DOOSAN PORTABLE POWER TECHNICAL SERVICE BULLETIN

Bulletin #: CMP-TSB-2008-001 rev.02
Date: February 16, 2009
Product: COMPRESSORS
Subject: 7/71-12/56 Vulcan coupling

Fig.1

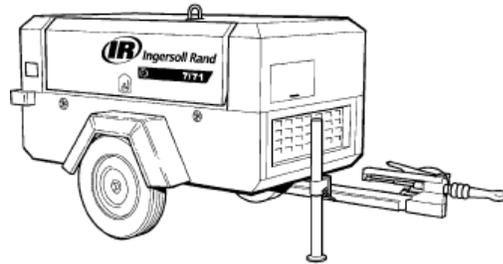
LORD coupling as used until November 2008 will be replaced by the Vulcan coupling for aftermarket use. LORD cpn 54755087 will supersede to 23348097.

From November 2008 onwards JD was replaced by the Yanmar engine and coupling was also replaced by a new LORD type which cannot be installed on pre 11-2008 JD powered machines.

Fig.7 consult instruction drawing 23345044

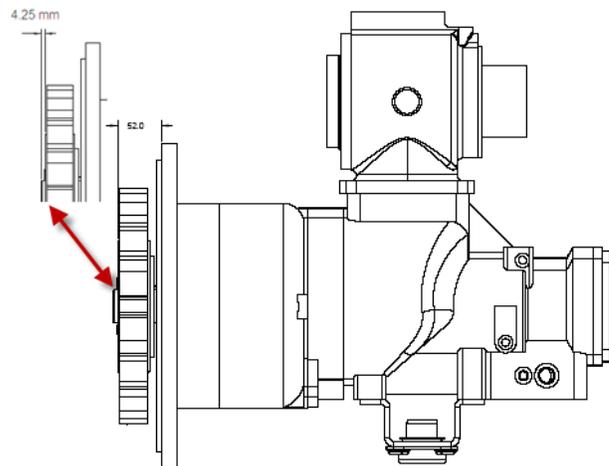
5. Install key on shaft.
6. Position coupling assembly over the air end shaft as indicated in (Fig.7)
4.25mm from front of shaft to front of coupling. (- 3,15/+6,15mm)
7. Alternately torque the two set screws to **36 ft/lb or 48.8Nm**.

**Rubber coupling should fully engage with outer ring.
Double check measurement as coupling should not rub on engine housing.**
